June 28, 1982

The Commission has issued the enclosed Amendment No. 70 to Facility Operating License No. DPR-23 for the H. B. Robinson Steam Electric Plant, Unit No. 2. The amendment consists of changes to the Technical Specifications in response to your application transmitted by letter dated July 10, 1981.

H. B. ROBINSON STEAM ELECTRIC PLANT, UNIT NO. 2

Amendment No. 70
License No. DPR-23

Fig. 6.2-1

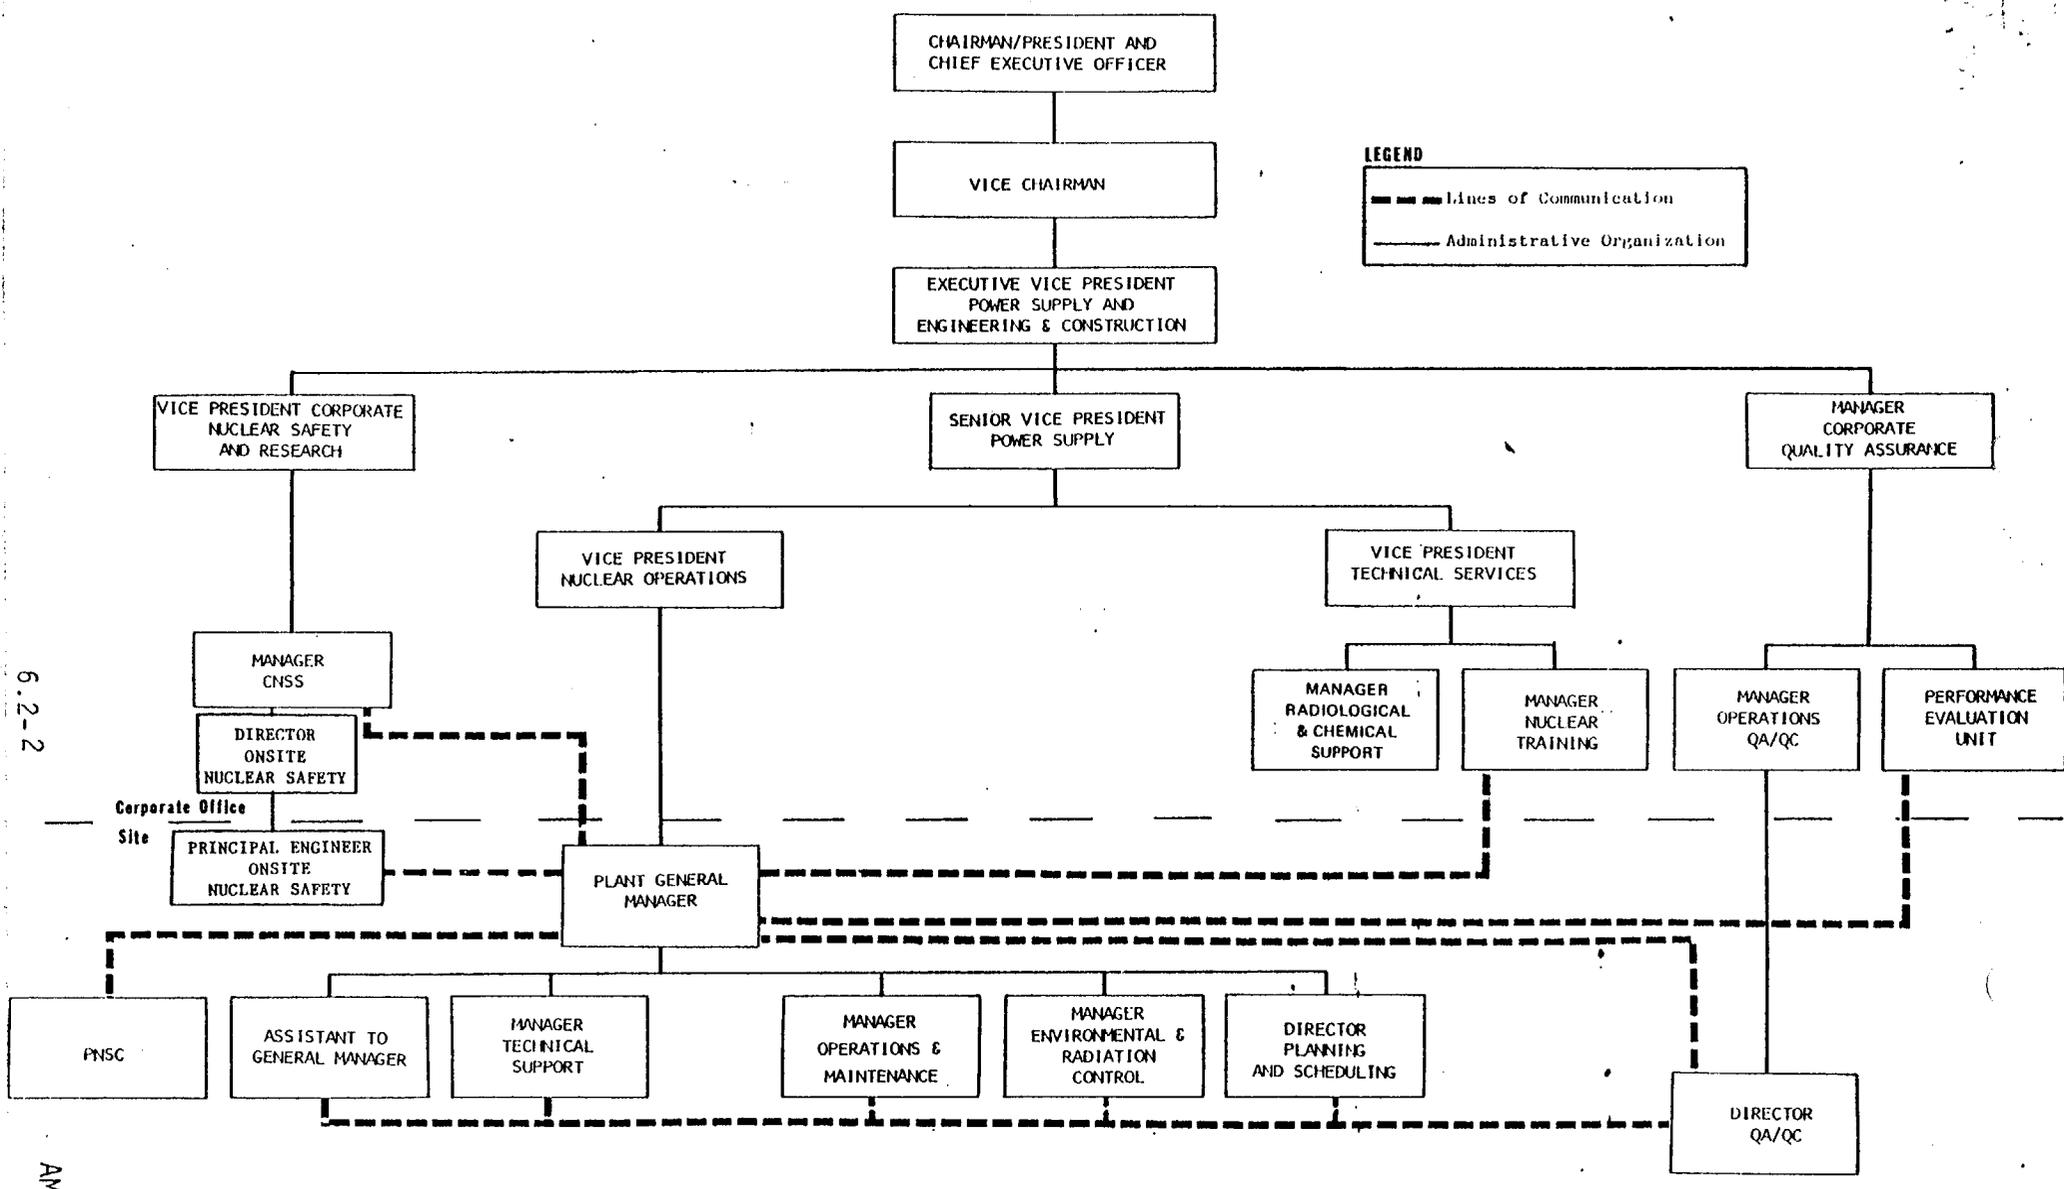
6.2.1 Offsite (Corporate) - The revised corporate report organization (TS Figure 6.2-1) is the same organization that was reviewed and found acceptable in conjunction with our evaluation of the organization and management of the Carolina Power and Light Company for operation of the Shearon Harris Nuclear Power Plant. Therefore, the offsite organization changes are found acceptable.

6.2.1 The offsite organization for facility management and technical support shall be as shown on Figure 6.2-1.

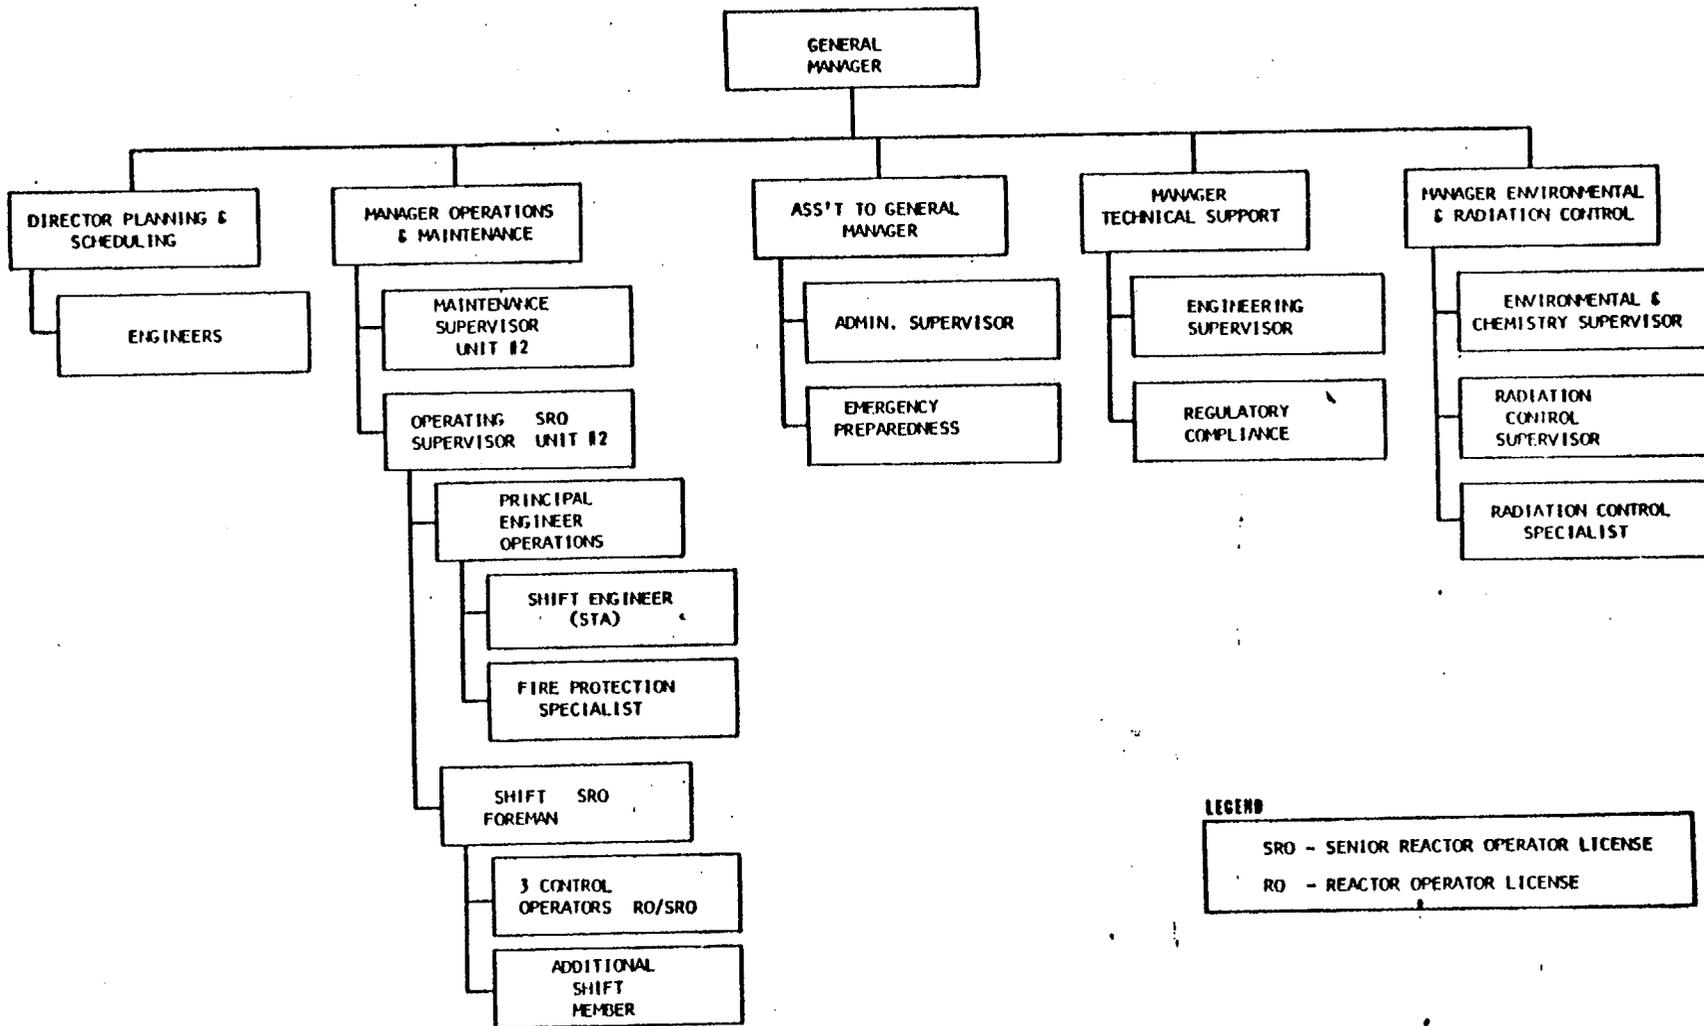
6.2.2 Onsite (Facility) - The revised TS Figure 6.2-2 for the new Robinson plant staff organization is similar but not identical to the proposed Shearon Harris plant staff organization discussed above.

Shearon Harris has a Manager, Environmental and Radiation Control; a Manager, Maintenance; and a Manager, Operations reporting to a Manager, Plant Operations who, in turn, reports directly to the General Manager. Robinson does not use the position of Manager, Plant Operations but instead combines the positions of Manager, Maintenance and Manager, Operations into a single position with the title Manager, Operations and Maintenance who reports directly to the General Manager.

The Manager, Environmental and Radiation Control, was changed to report directly to the General Manager in the Robinson organization. This change is in accordance with the criteria of NUREG-0731, "Criteria for Utility Management and Technical Competence," and Regulatory Guide 8.8, Section C.1.b(3).

We find that these differences are due to the fact that the Robinson plant staff is organized to support only one unit whereas the Shearon Harris plant staff is organized to support several units. We conclude that the Robinson plant staff as shown in proposed TS Figure 6.2-2 is acceptable.

6.2.2 The facility organization shall be as shown on Figure 6.2-2 and:
